Staff Report

Re: Petition PLNHLC2017-00722, TAG Row House Development

NEW CONSTRUCTION – 3-UNIT ROW HOUSE

PROPERTY ADDRESS: 613 East 100 South

Image A

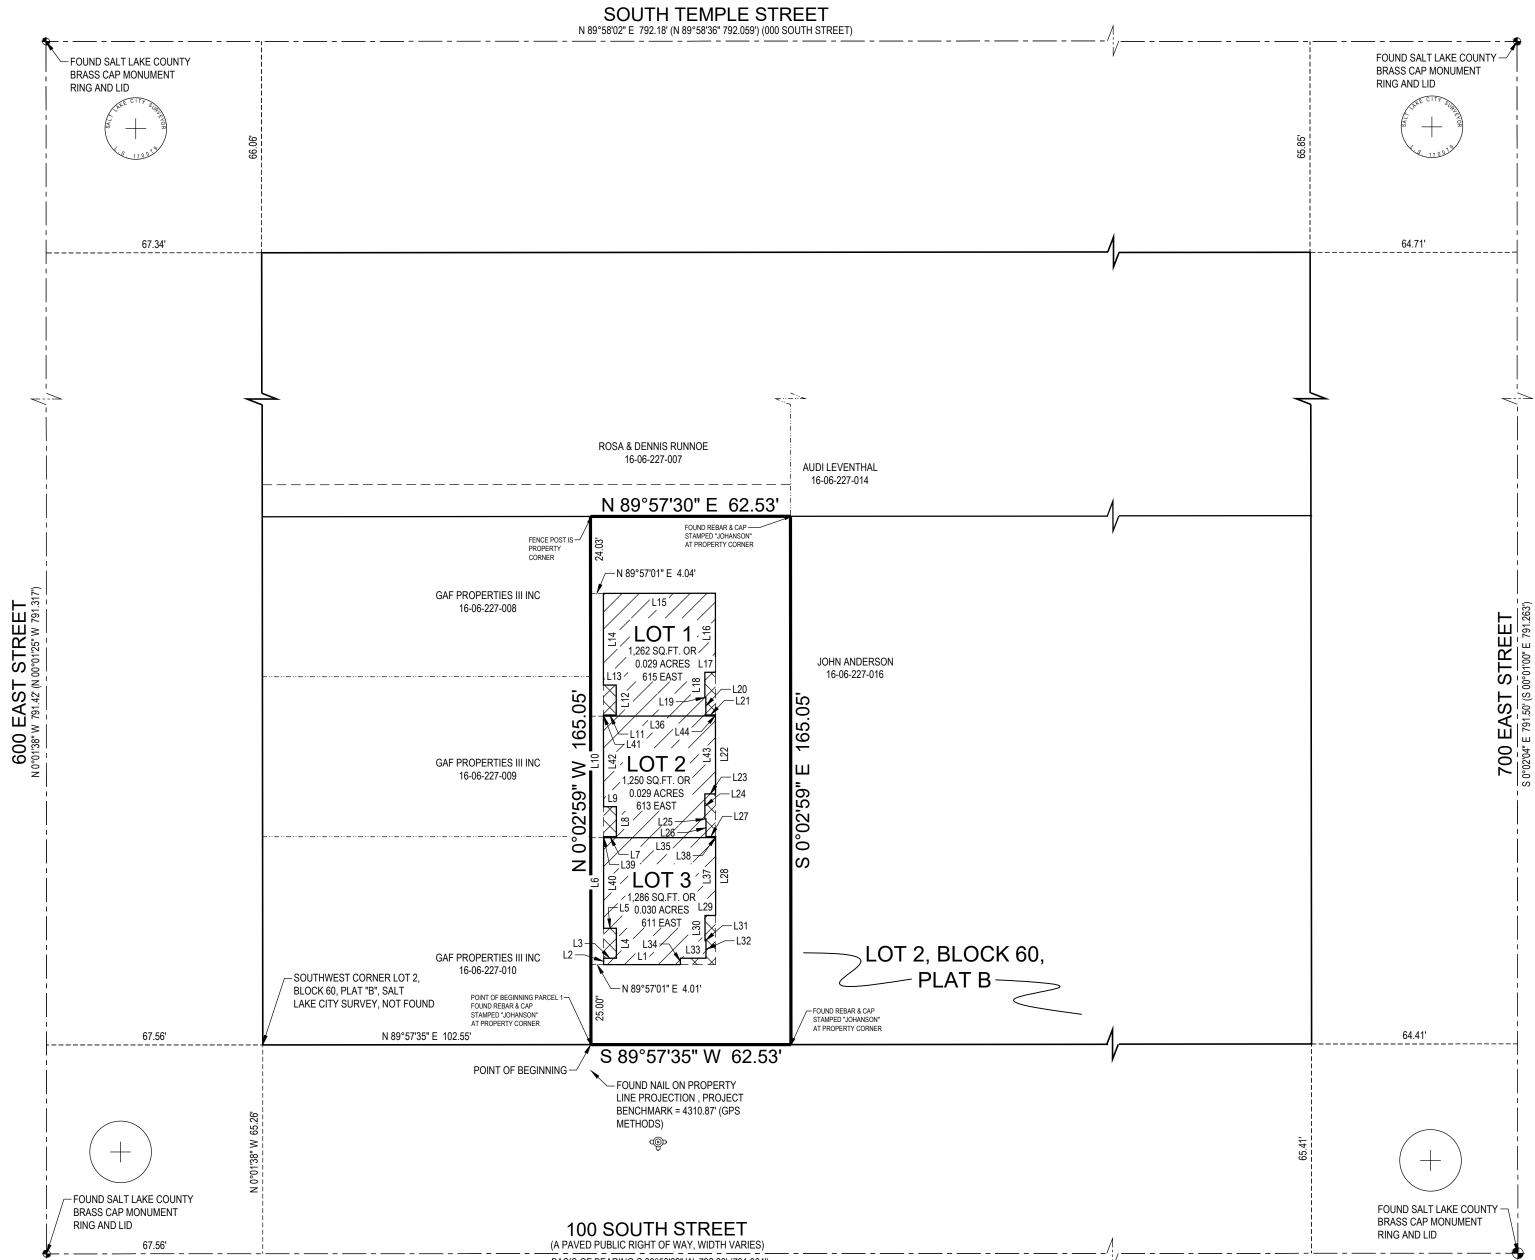
• A landscape plan has been provided and contains more landscaping on the east and west sides of the building to act as a buffer between the neighboring properties (Image A & B). An existing retaining wall and fence will be used on the west elevation (Image A) and will be enhanced by new shrubs for landscaping. Along the east property line an existing stone retaining wall (Image B) along with a new retaining wall will be used. These retaining walls will be lined with a series of shrubs to provide adequate landscaping and a natural barrier between the two neighboring properties (Image C).

A000

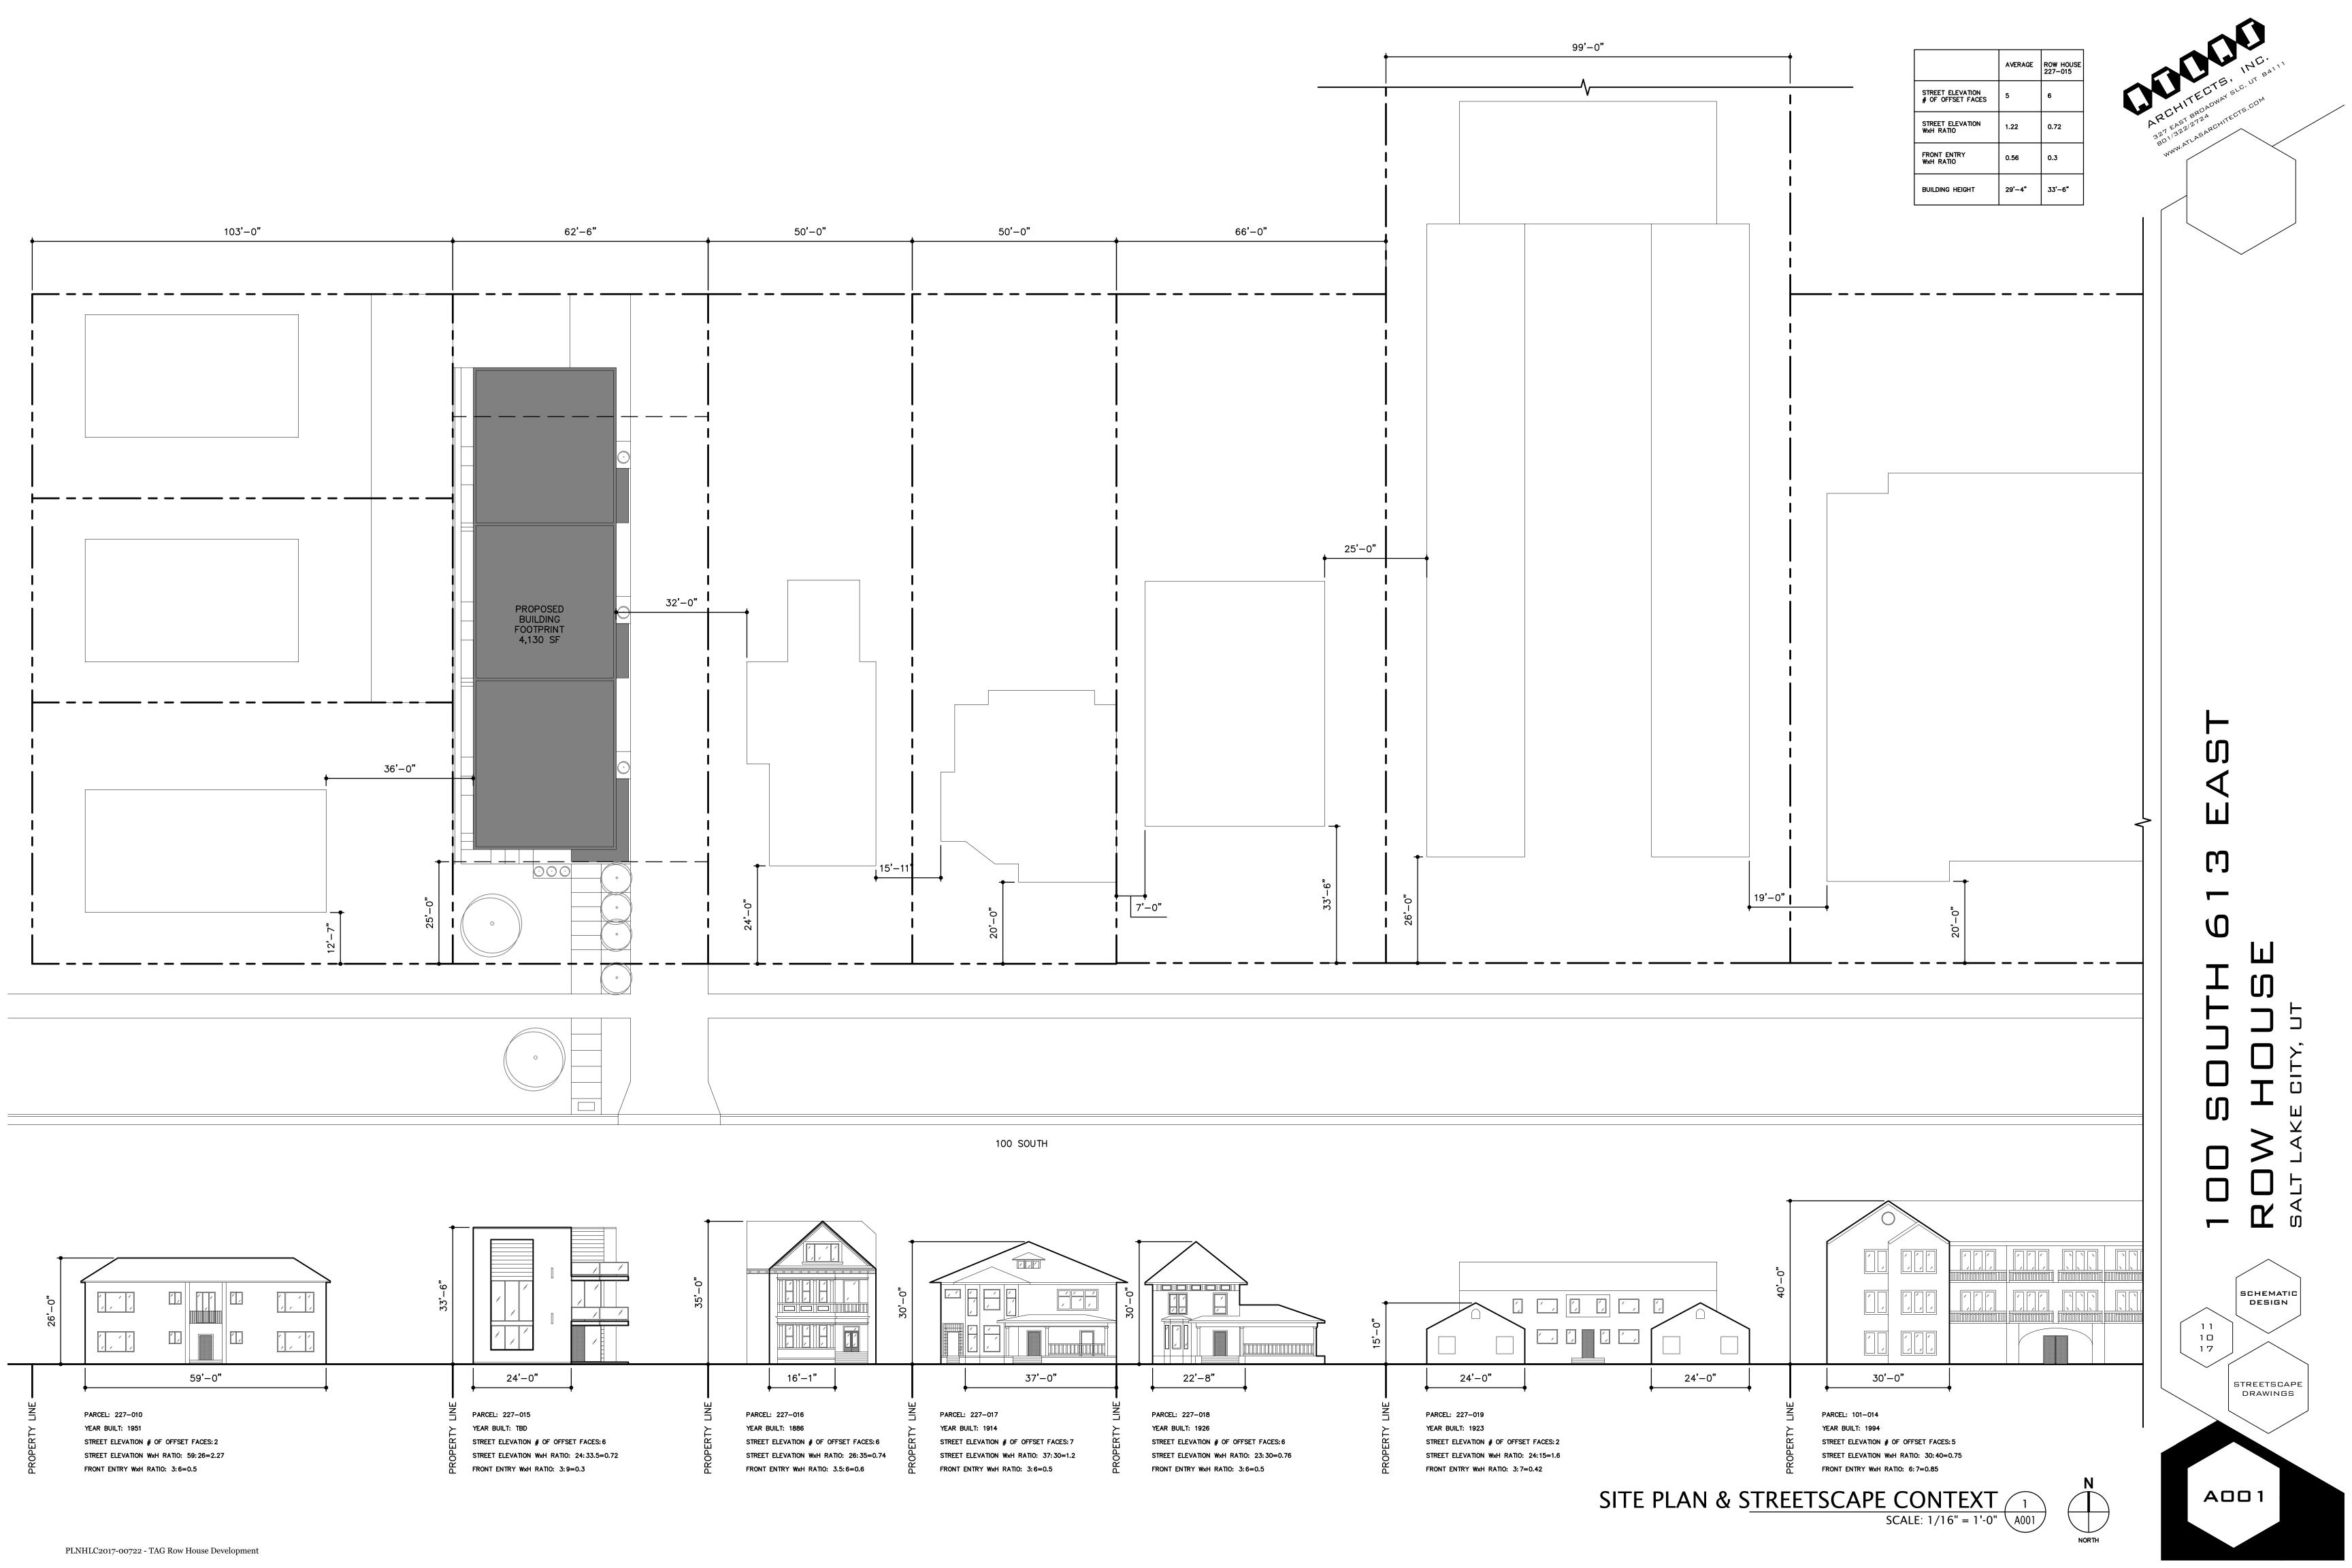
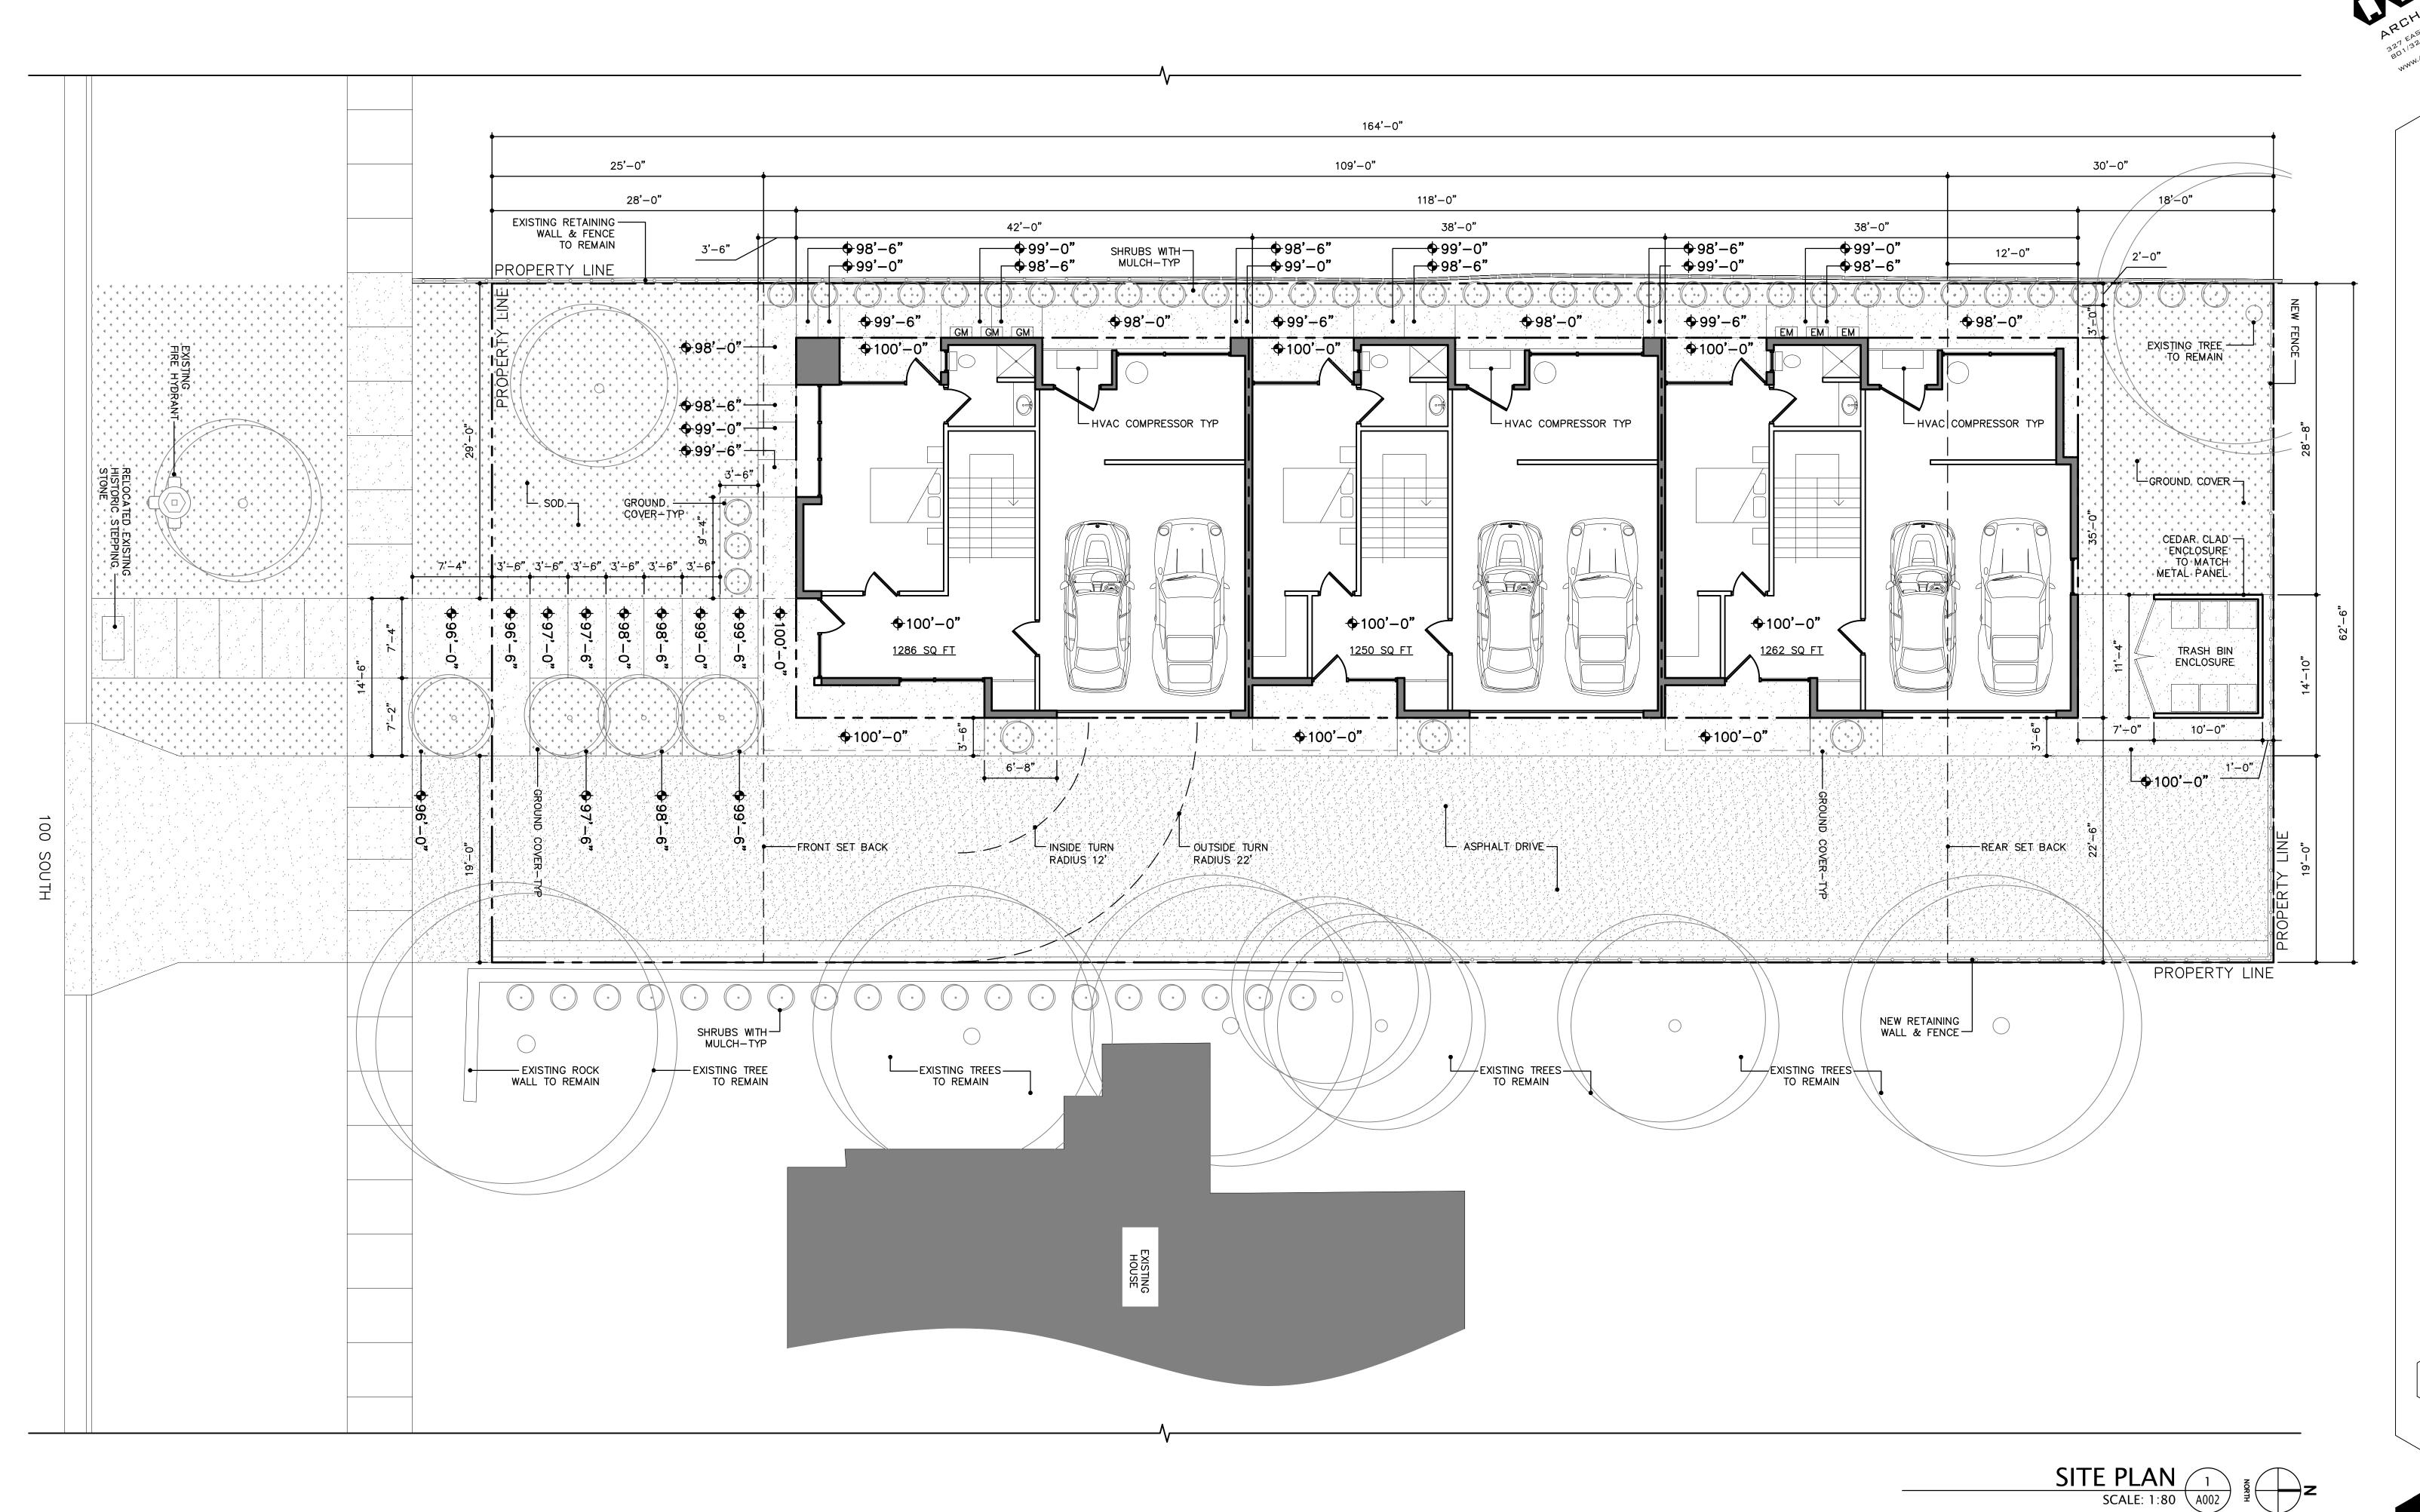
- The south facade has been further articulated by recessing the walls, and deepening the window reveals. Windows "A" & "B" have been recesses by two feet to provide a level of protection from the southern sun. In so doing this recess also creates more visual interest along this facade. The south elevation of this project currently has a total of six offset surfaces which is in par with the level of building articulation along this

- A top and base has been established by continuing the revised design language of the building on all four elevations. A repeating orthogonal brick arch with a 3'-0" top exists on every elevation. The top of the arch contains a 4" metal parapet and sits on a 6" concrete base. The metal parapet will be finished to match the black metal panel on the building. (Refer to A000, A200 & A201)

- Horizontal contrast and emphasis is created by running the metal panel horizontally and through the fascia of the balconies. On the south elevation a tripartite window has been introduced to contrast the vertical proportions of the brick volume. (Refer to A000, A200 & A201)

- Recessed walls have been carried out on west facade. (Refer to A000 & A201)
- Landscaping has been installed along the south, east & west side of the property.
 (Refer to A002)
